Title - Sujet CCTV EQUIPMENT AT MILLHAVEN	
Solicitation No. - N° de l'invitation 21120-147892/A	Amendment No. - N° modif. 003
Client Reference No. - N° de référence du client 21120-14-2007892	Date 2015-03-04
GETS Reference No. - N° de référence de SEAG PW-\$\$HN-461-66520	
File No. - N° de dossier hn461.21120-147892	CCC No./N° CCC - FMS No./N° VME
Solicitation Closes - L'invitation prend fin at - à 02:00 PM on - le 2015-03-13	Time Zone Fuseau horaire Eastern Daylight Saving Time EDT
F.O.B. - F.A.B. Plant-Usine: <input type="checkbox"/> Destination: <input type="checkbox"/> Other-Autre: <input type="checkbox"/>	
Address Enquiries to: - Adresser toutes questions à: Hallman, Patti	Buyer Id - Id de l'acheteur hn461
Telephone No. - N° de téléphone (819) 956-7390 ()	FAX No. - N° de FAX () -
Destination - of Goods, Services, and Construction: Destination - des biens, services et construction:

**STATEMENT
OF
TECHNICAL REQUIREMENTS

MILLHAVEN INSTITUTION**

Questions and Answers Part 3

Attached is a site map for reference, (this map also located in Appendix H)

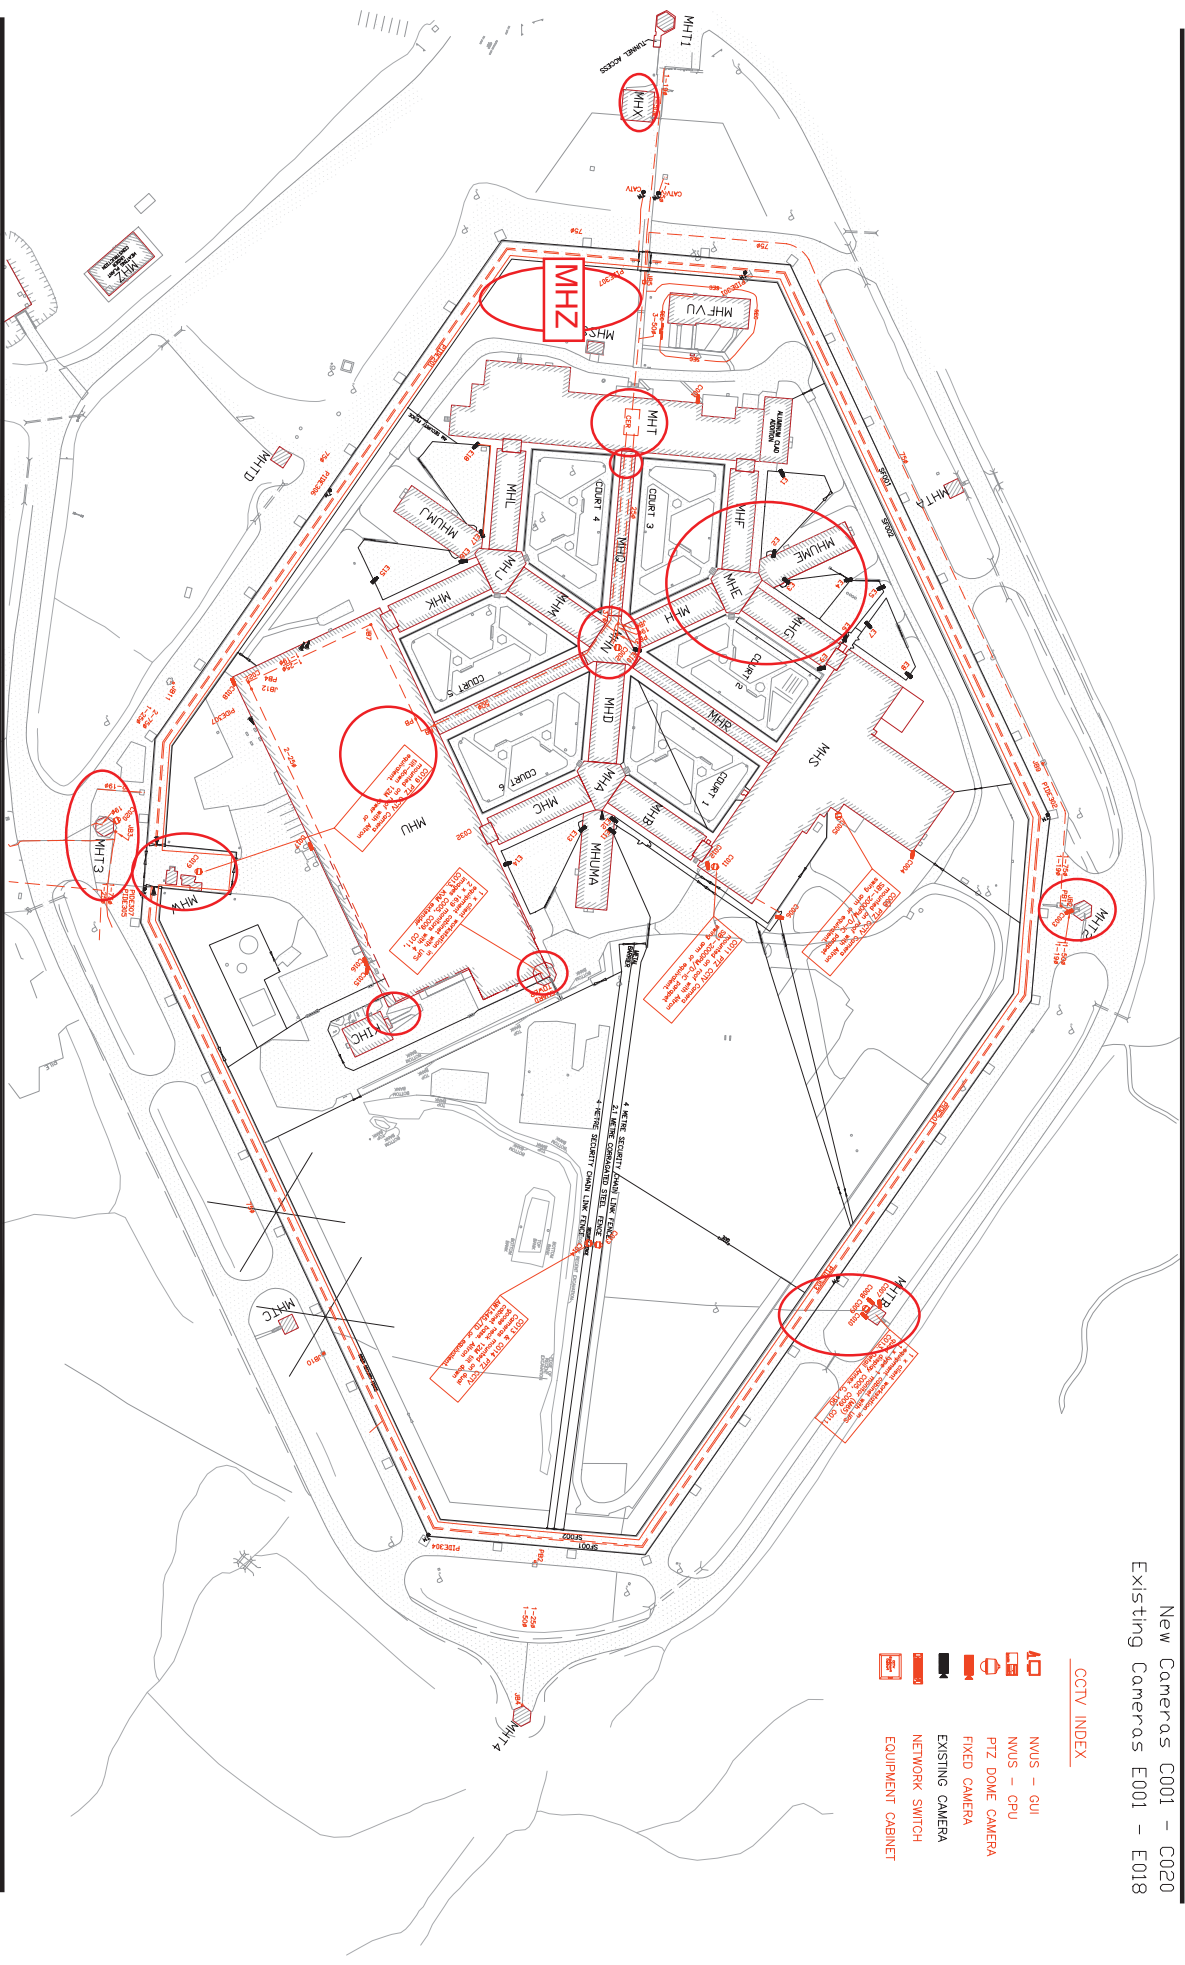
Some points of interest in today's site bidders meeting.

Corresponding map identified in red

1. GI building (MHZ)
2. T building (MHT)
 - T169
 - M CCP
 - V&C
 - CER
 - Main
3. N control (MHN)
 - N basement
 - A basement
 - E basement
 - J basement
 - E control
4. E unit (MHE)
 - E unit management offices
 - 1G
5. S building (MHS)
 - S control
 - S basement
 - Segregation
 - Hospital
 - S Gallery
6. U building (MHU)
 - U control
 - U gallery
 - Kitchen gallery
 - U tower
7. ID building (MHX)
8. 2 Tower (exterior only)
9. B outpost (interior)
10. 3 Tower (exterior only)
11. Sally port (MHW)
